Production: **Airence-7 Master Power**

Production: Airence-Telco

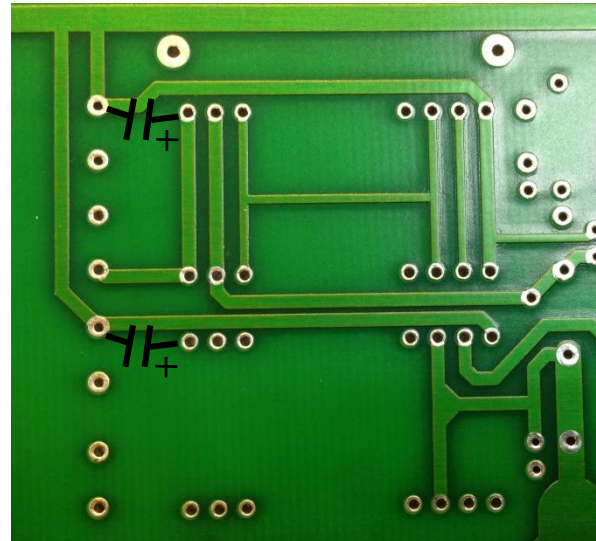
3. Place the following components after the wave soldering process according to the picture below

Part	Part	Part Number
C50	220uF/63V	10400293
C63	220uF/63V	10400293

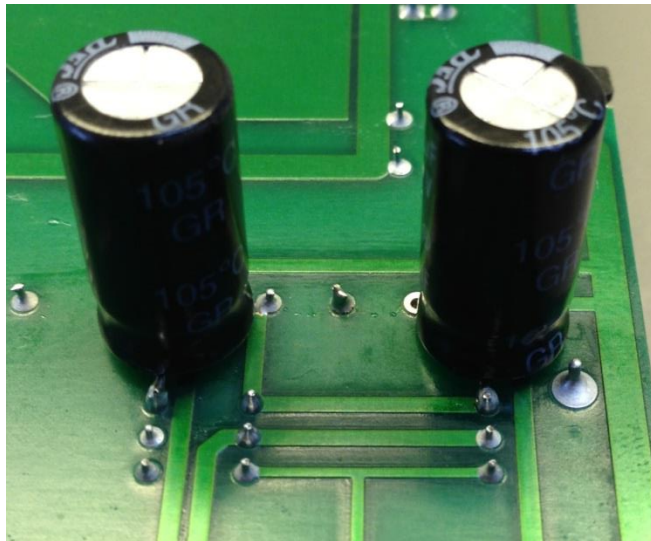
Modification to correct for varying coil voltage to relay RL2.

1. Replace the following components during assembly of the PCB.

Part	Old Part	Old Part Number	New Part	New Part number
R6	820	10350728	470	10350725
Z6	8V2 Zener	10250352	9V1 Zener	10250373

The components are marked with a red cirkel
